Agenda – Appeal Committee – January 28, 2026

Item No. 2 Appeal – Variance – 36 Roslyn Road
(Fort Rouge-East Fort Garry Ward)
File DAV 204666A/2025D [c/r DAZ 220/2025]

ADMINISTRATIVE REPORT

Title: DAV 25-204666\D – 36 Roslyn Rd

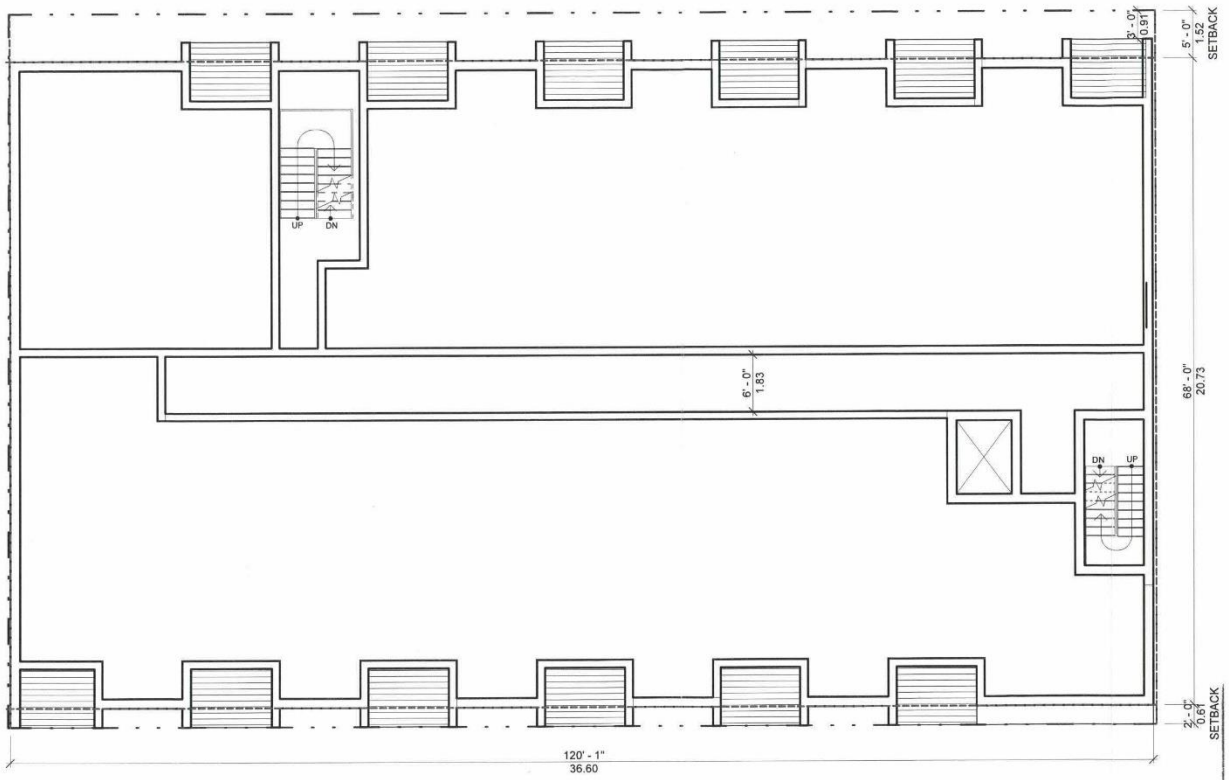
- The application intends to construct one 72-unit multi-family building, which would:
    - Be eight stories in height, including a rooftop patio.
    - Have a 0’ front yard setback to Roslyn Road.

- Have a 0’ east corner side yard setback to Bryce Street.
    - Have a 0’ rear yard setback to the lane.
    - Have a 5’ west side yard setback.
    - Be clad primarily with Tyndall stone and brick.

- The site plan also shows:
    - A garbage enclosure located at the southwest corner of the subject site.
    - A total of 21 parking spaces, including six accessible stalls, primarily located in covered parking at ground floor.

- 52 secure, indoor bicycle parking spaces.
    - A total of 0 trees and 44 shrubs.
- No affordable units – which would normally be required per the City of Winnipeg’s Density Bonus Program – are proposed.

The proposed building includes a reduced front yard to Roslyn Road of 0', and a reduced east corner side yard to Bryce Street of 0'. While the surrounding area is characterized by many large buildings, most buildings in the immediate vicinity – and all of the buildings that are at least

- In addition to the existing precedents for setbacks, landscaping in front yards is a common feature on this block, requiring some yard space to maintain plantings. As currently shown, the proposal does not include any trees, and it does not include any plantings facing Roslyn Road.

- The application notes that zero trees will be provided on site, but multiple trees will be provided in the public boulevards. The City already requires three trees in the Roslyn Road boulevard and three trees in the Bryce Street Boulevard. These public boulevard plantings are not considered a trade off for the required street edge landscaping on the private property.

- Given the proposed development provides parking off the rear lane, it is not possible to provide a landscaped buffer between the rear of this property and the adjacent residential zoning district. No landscaped buffer between parking areas in at the rear of properties and adjacent residential development is a common feature of this neighbourhood, including this lane.

- For these reasons, a front yard of 10’ and an east corner side yard of 8’ are supportable, as this would enable the building to be located close to the street-fronting property lines, it would provide separation between one of the taller buildings in the neighbourhood and the public sidewalk, it would enable space for landscaping, and it would acknowledge the existing precedent in the area.
